Memorandum

To: Planning Commission Members
From: Elizabeth J Corwin, PE, AIPC; Planning Director
Date: February 19, 2026
Re: SPR25-001
Applicant: Steve Kolber/Kolbrook Design. Owner: OM Group
140 W Highland Road
PIN 11-22-301-007

Parcel #	11-22-301-007
Zoning:	C-1, Local Commercial Zoning District
Address:	140 W Highland
File#:	SPR 25-01
Request:	Site Plan Review for Jimmy John/Dunkin
Applicant:	Steve Kolber, Kolbrook Design
Owner:	OM Group

KP-J ARCHITECTS & ENGINEERS
GRADING PLAN
 SECTION: 22
 RANGE: 7E
 140 W. HIGHLAND ROAD
 TOWNSHIP: 3N
 HIGHLAND TOWNSHIP
 OAKLAND COUNTY
 MICHIGAN

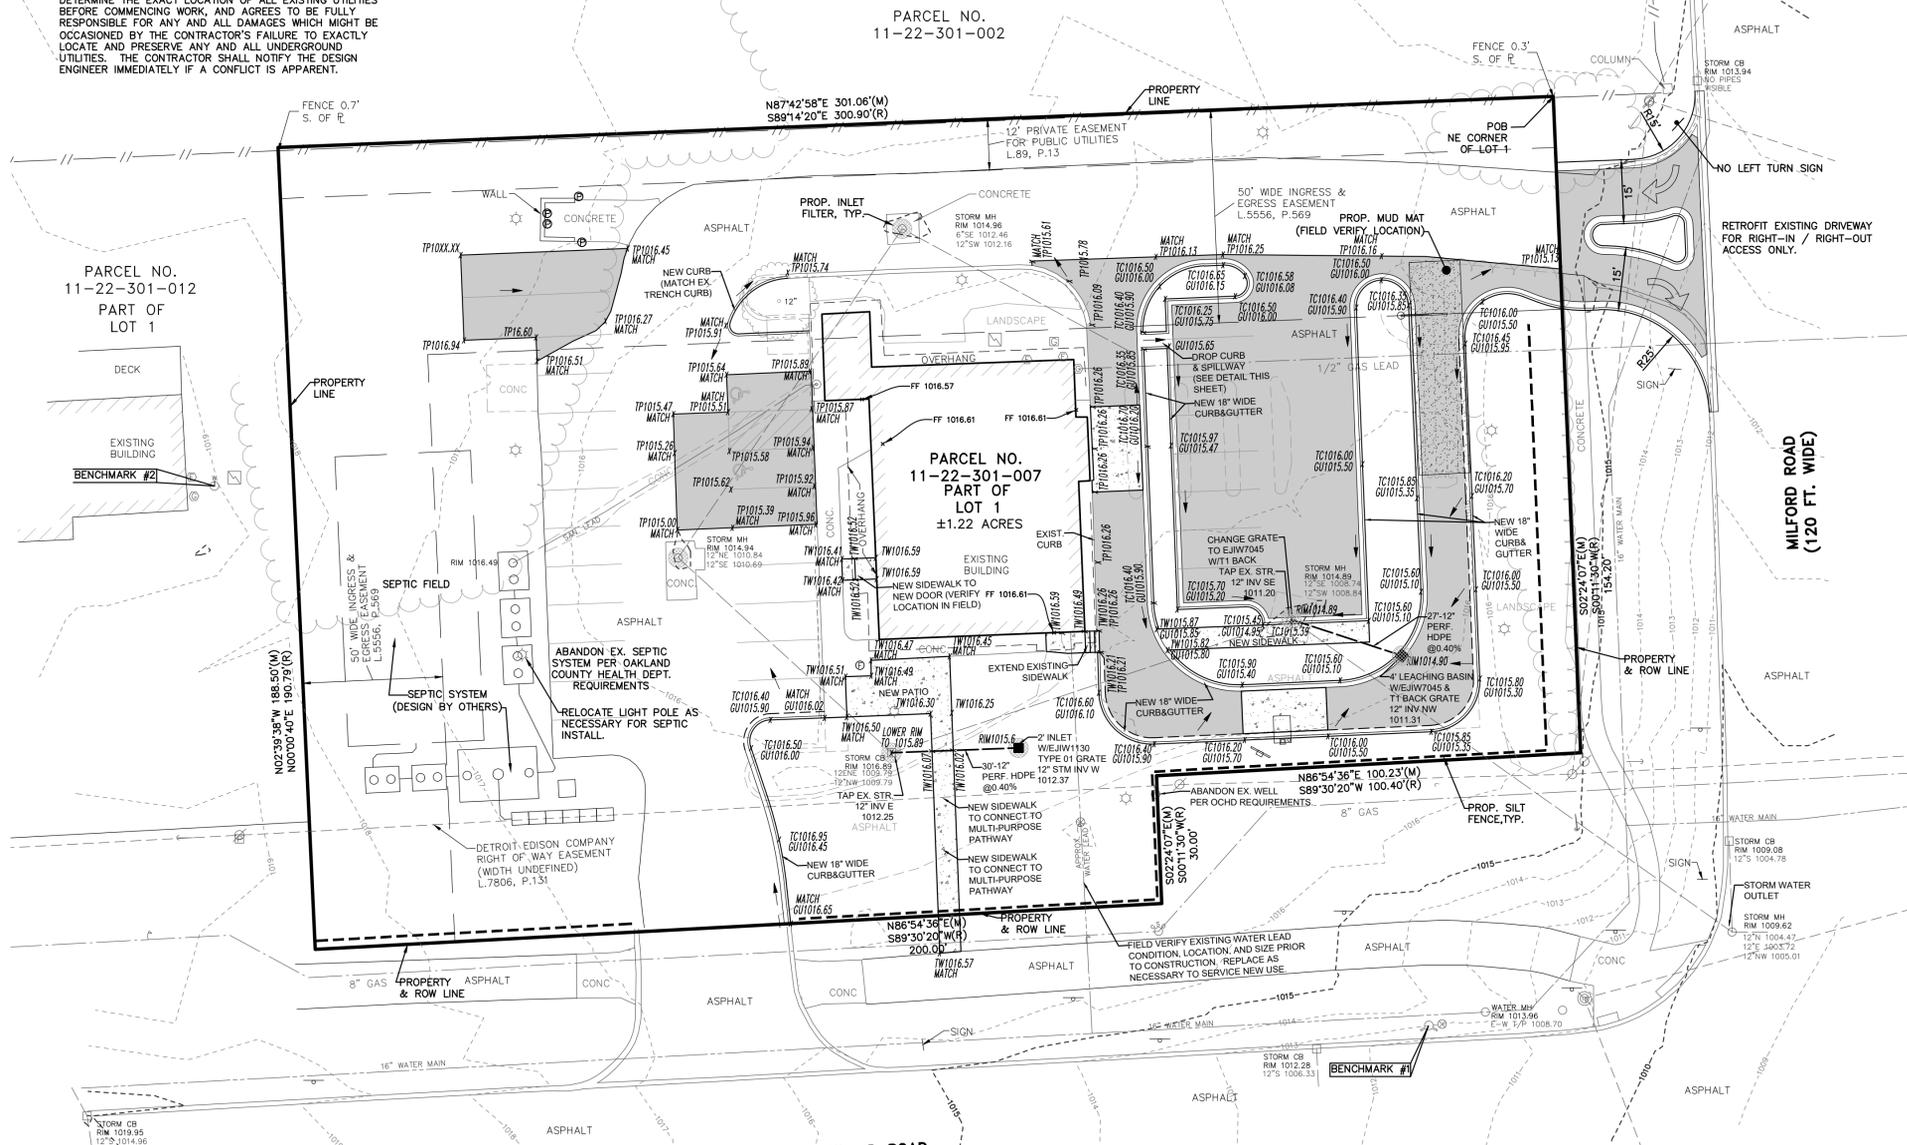
The Milford Road driveway geometry has been modified to address Road Commission for Oakland County (RCOC) requirements restricting turns in and out of the site.

1 LANDSCAPE PLAN
SCALE: 1" = 20'-0"

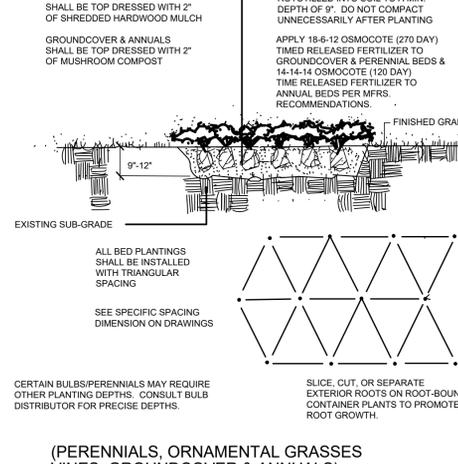
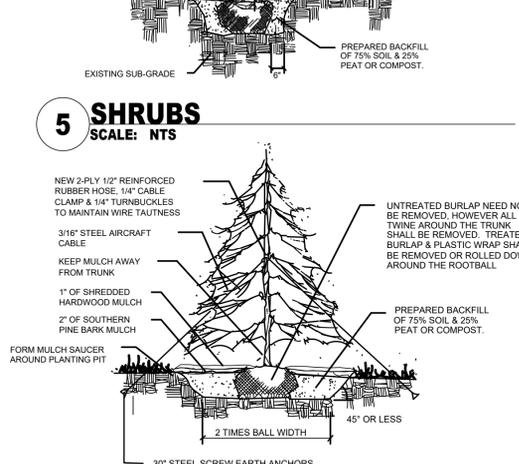
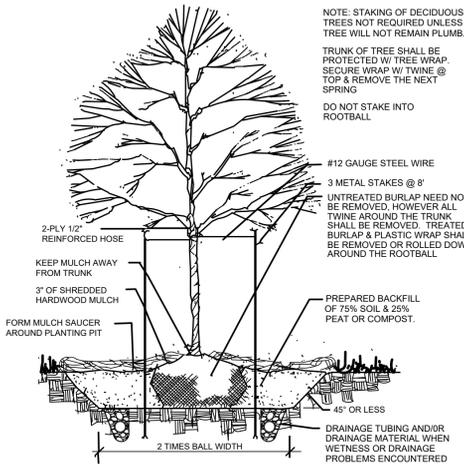
The landscaping plan has been altered to better indicate the limits of mulch beds. The plans do not include the fencing discussed previously. The Supervisor believes the cemetery aesthetics and maintenance needs are better served by keeping the existing chain link fence so as to not "wall off" the cemetery. The landscaping at that property boundary is moved back to the fence to address your concerns about snow removal and maintenance. The landscaping plan is compliant with the zoning ordinance restrictions.

Mr. Charlick asked about the landscaping plans. He noted that there is not a good explanation of the planting beds provided for the trees. Ms. Corwin noted that it would seem difficult to maintain the mowing given the spacing of the trees. Mr. Temple thought it was critical to provide an appropriate screen for the cemetery, so that visitors are not disturbed by the commercial activity. Mr. Curtis affirmed that this was also an issue for Mr. Smith. Mr. York thought this landscaping proposal was not as robust as they had expected or hoped for.

Mr. Temple asked about the cloud areas on the drawing. These areas will be selectively cleared of invasive species and any diseased plants. He asked if a fence might be considered at the north property line. Mr. Temple thought smaller plants against the backdrop of the fence might be more appropriate. Ms. Corwin noted that the Supervisor had expressed a preference for a fence at one time. Mr. Charlick also noted that the landscaping proposed might be vulnerable to the plowing operations for the site. Mr. York noted that it might be necessary for the snow to be removed from the site.

1 PHOTOMETRIC PLAN

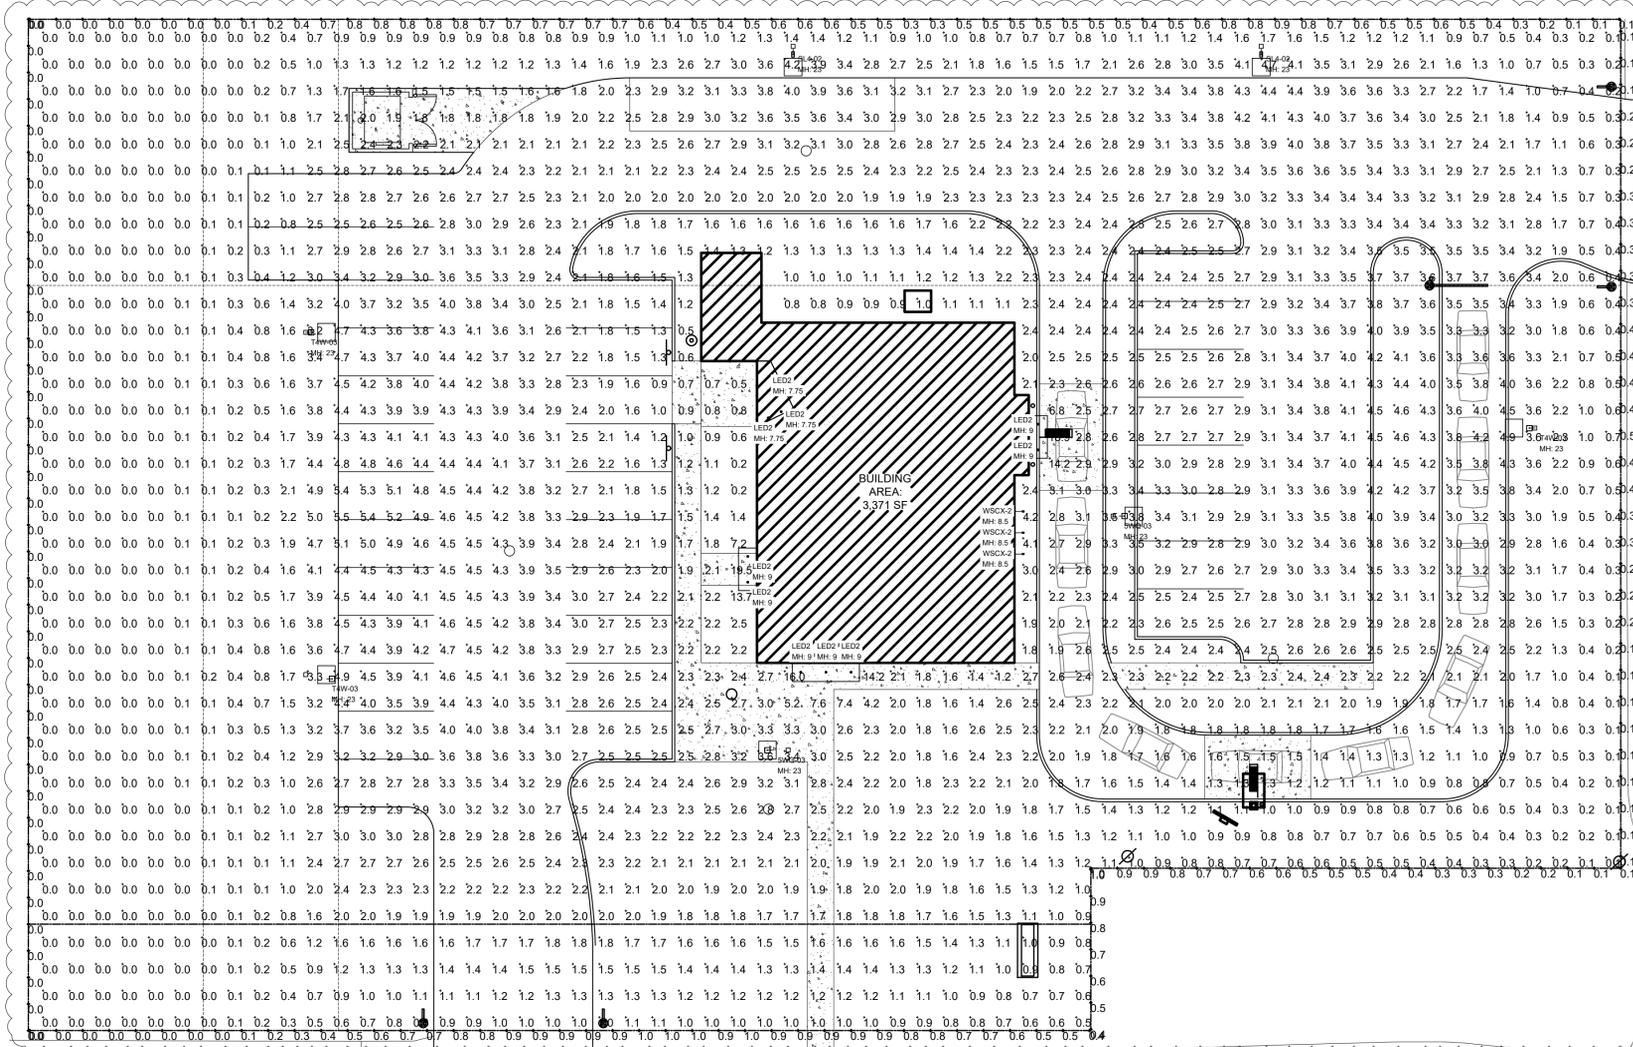
They have addressed the issue of lighting levels at the property lines by changing the luminaires. The pole mounting heights are compliant with the zoning ordinance regulations including a statement that the lighting levels will be reduced after 11:00 p.m.

Mr. Charlick asked about the lighting, since it exceeds the levels allowable at the property lines. Mr. Rucker explained that their lighting designers are reanalyzing the lighting levels and may suggest new fixtures. They hope to use the existing pole locations.
